SUBJECT: COMANCHE PEAK NUCLEAR POWER PLANT, UNITS 3 AND 4
DOCKET NUMBERS 52-034 AND 52-035
RESPONSE TO REQUEST FOR ADDITIONAL INFORMATION NO. 5092
(SECTION 3.8.4)

RAI NO.: 5092 (CP RAI #185)

SRP SECTION: 03.08.04 - Other Seismic Category I Structures

QUESTION NO.: 03.08.04-86

Figure 1

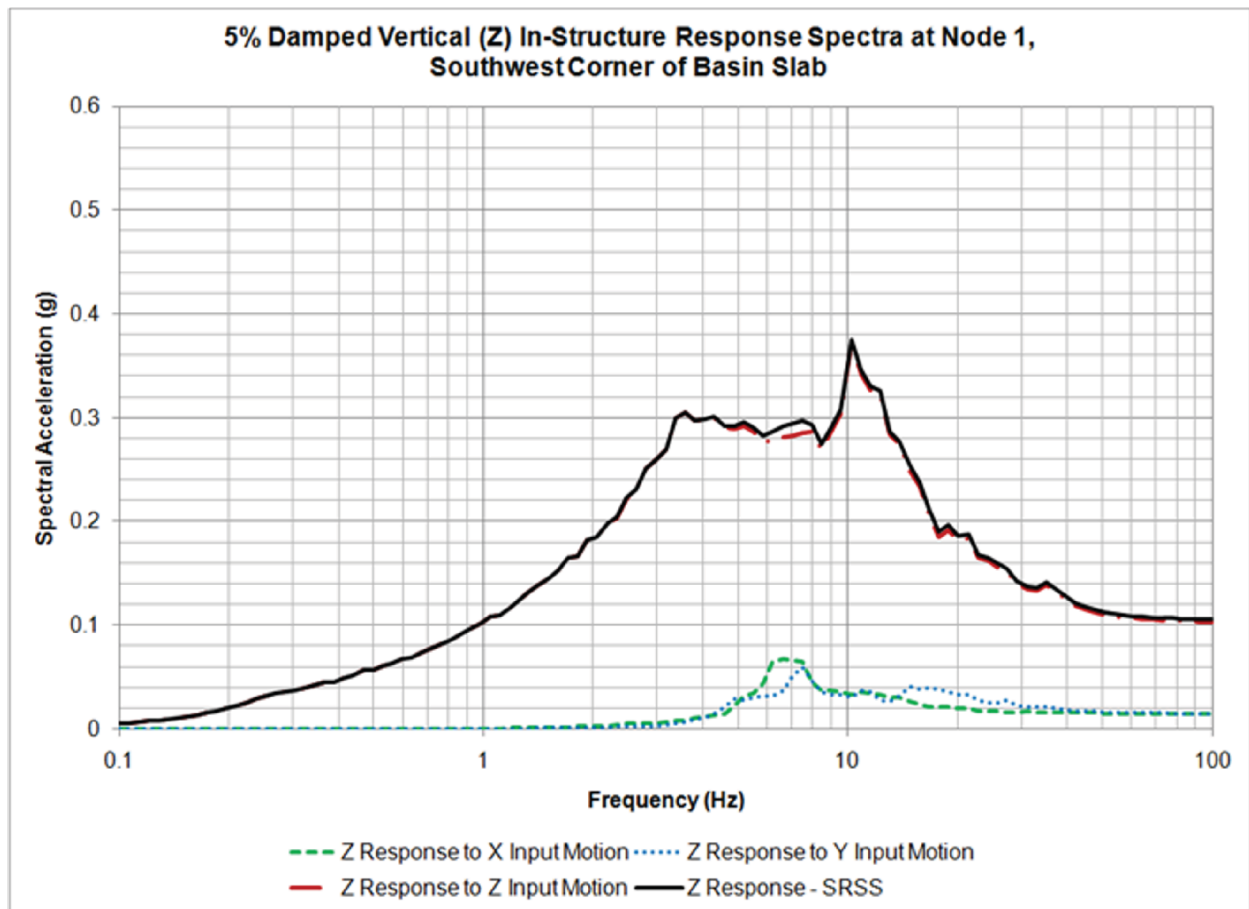
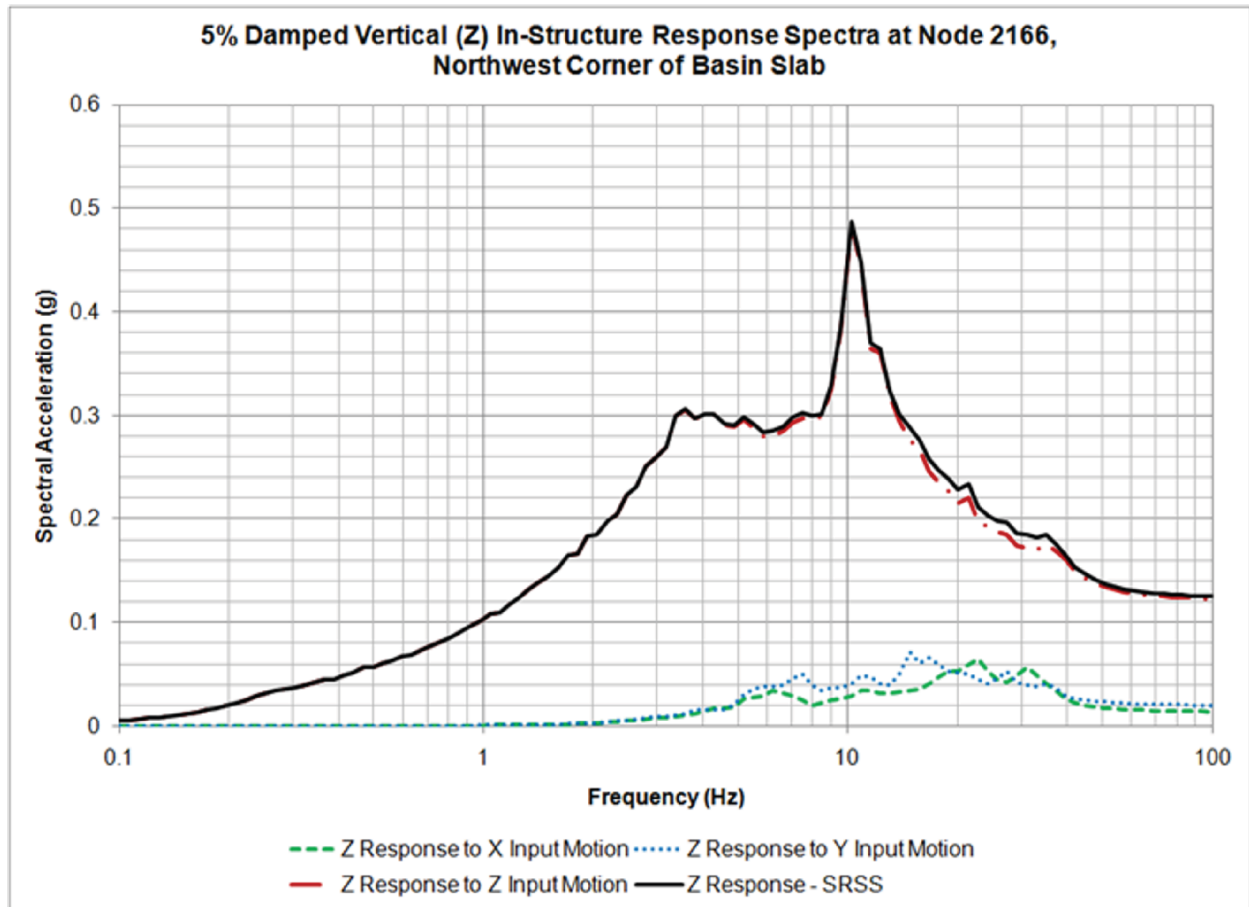
The Applicant is requested to provide information that explains how the fluid masses corresponding to the base rocking motion are calculated and included in the model, taking into account the staff's comments cited above.

The SSI analyses use a full three-dimensional structural model supported by the free field soil without nodal constraints and is therefore capable of modeling rocking motion. The extent of SSI-induced rocking for the UHSRS is examined through a comparison of the vertical best-estimate soil 5% damped in-structure response spectra components at node 1, located at the southwest corner of the basin slab, and node 2166, located at the northwest corner of the basin slab. These comparisons are shown in Figure 1 and Figure 2, respectively. Since these locations are at edge corners stiffened by the outer walls, any rocking of the structure due to horizontal input motion is observed as vertical motion of the corner node.

As shown in the figures below, there is very little rocking present in the structure, on the order of 0.02 g peak ground acceleration and nearly zero in the low frequency regions that would excite convective modes. The lack of significant rocking is consistent with the stiff subgrade of this foundation supported on limestone.

Since the UHSRS is not experiencing significant motions representative of base rocking, additional consideration of modeling to capture the effect of base rocking on hydrodynamic pressures is unnecessary.
